Pre-Hearing Statement of Advisory Neighborhood Commission 6C

District of Columbia Board of Zoning Adjustment Appeal No. 19550

This appeal relates to 1125 7th St. NE, also known as square 886, lot 35 (“the Property”) in the RF-1 zone. The Property’s owner of record is Atlas Squared, LLC, 7926 Jones Branch Drive, Ste. 600, McLean, VA 22102-3373. The Property lies entirely within the boundaries of ANC 6C.

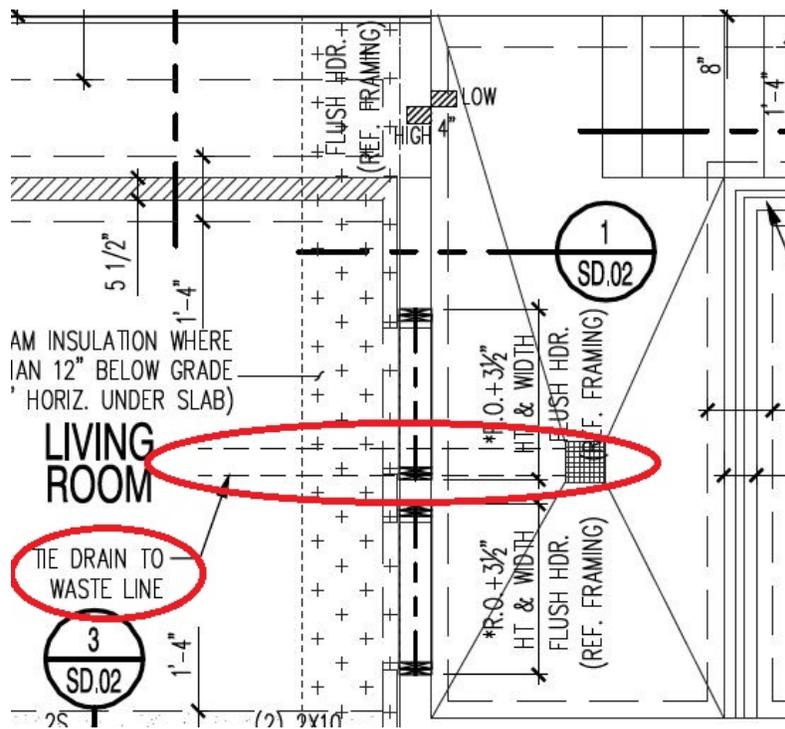
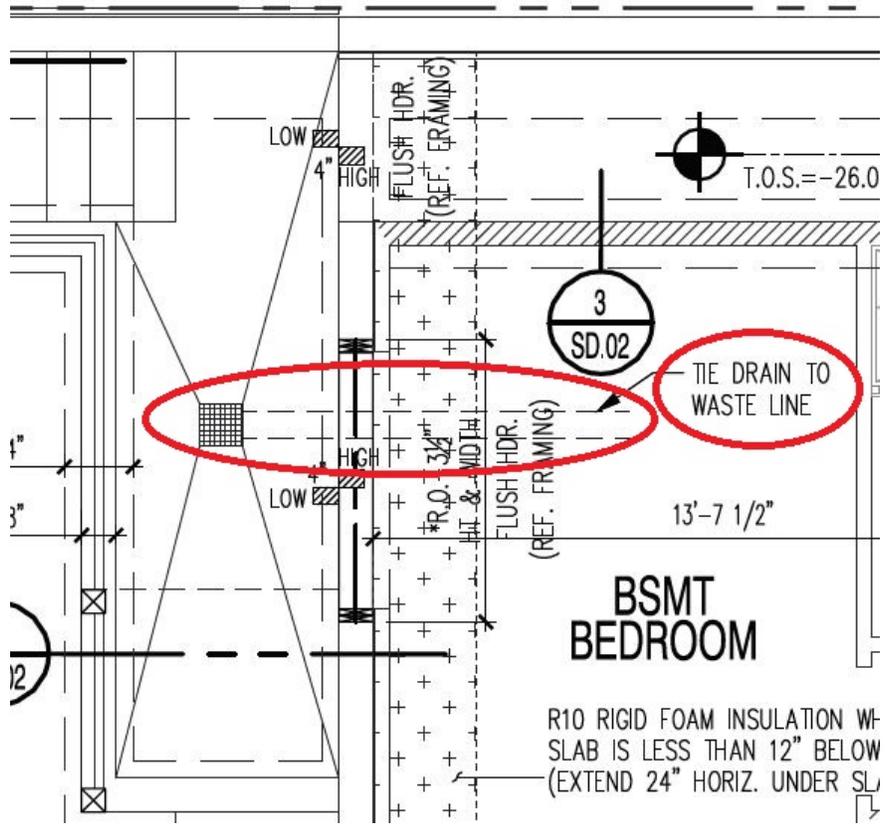
In fact, this 40% figure is patently false. Most obviously, each and every one of the “wells” shown on the plat consists not of soil allowing water percolation, but instead of impervious concrete sloped toward a drain tied into the waste line. Permit drawing S.01 (ANC 6C SOA Tab D) depicts this unambiguously in multiple places:

These areaways, which have a combined area of over 300 square feet, in no way satisfy the definition of “pervious surface” in the regulations. As a result, the applicant’s claim that 40% of the lot is “permeable area” is incontrovertibly false. The pervious-surface figures on the plat must therefore be disregarded in their entirety, and the individual plan drawings examined for explicit indications that pervious surface is planned.

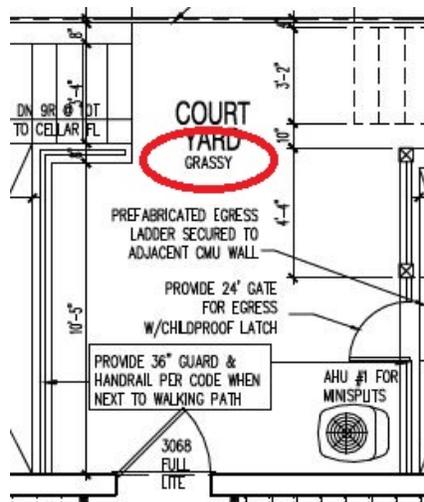
Indeed, the lone pervious-surface marking we have located in the plan drawings is for the central courtyard (sheet A1.1), which labels it “grassy”:

Although the plans do not provide specific dimensions for this portion of the Property, our measurements indicate that this area covers only 156 square feet, or less than 6.7% of the overall lot area. (This calculation generously ignores the air-conditioning unit seen above.) Even if our calculations were off by 100%—and we respectfully submit that they are not—the labeled “grassy” area would still fall far below the minimum 466 square feet of pervious surface required by the zoning regulations.²

FIGURE 4.2(a) Chimney or Vent Termination Less Than 10 ft (3.1 m) from Ridge, Wall, or Parapet.

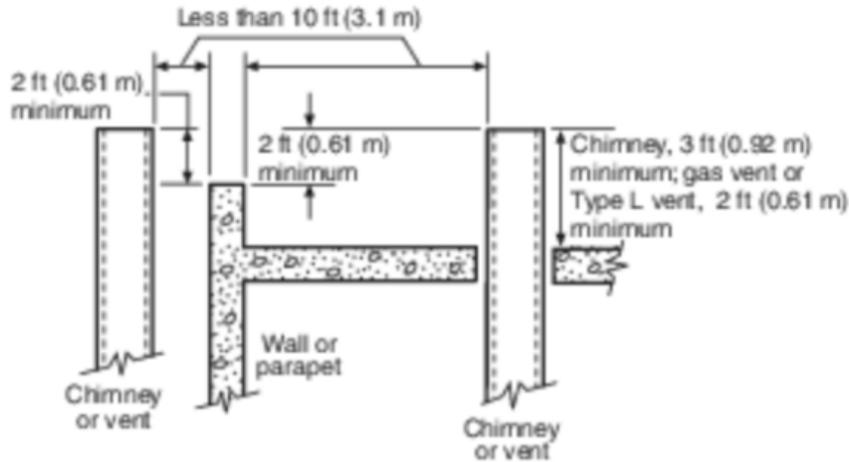
Association) 211. That standard requires a vent to rise at least two feet above any wall or parapet less than 10' away:

However, the vent at 1123 7th is far less than 10' from the lot boundary at which the Property owner proposes to construct a face-on-line wall.

Sheet A1.1: Cellar-unit water heaters in rear structure (left) and front structure (right)

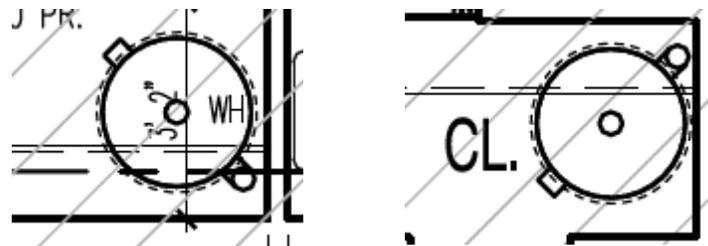
Sheet A1.1 of the Permit drawings (ANC 6C SOA Tab D; Case Exhibit 3D) shows a functioning separate unit on the cellar level of each of the two (front and rear) structures. Each cellar unit has a bedroom. Each cellar unit has full bathroom. Each cellar unit has its own laundry facilities (marked "W/D") separate from the laundry facilities in the front and rear upper units. Each cellar unit has a "living room" featuring a

refrigerator, dishwasher, and large kitchen-style sink. And each cellar unit has its own tankless water heater separate from those on the first floor (front and rear):

Regardless of whether the Board considers these cellar units to be principal units or accessory units,³ they bring the total number of units to double the legal maximum. Because the Permit violates the cap on the allowable number of units, the Board should order its revocation.
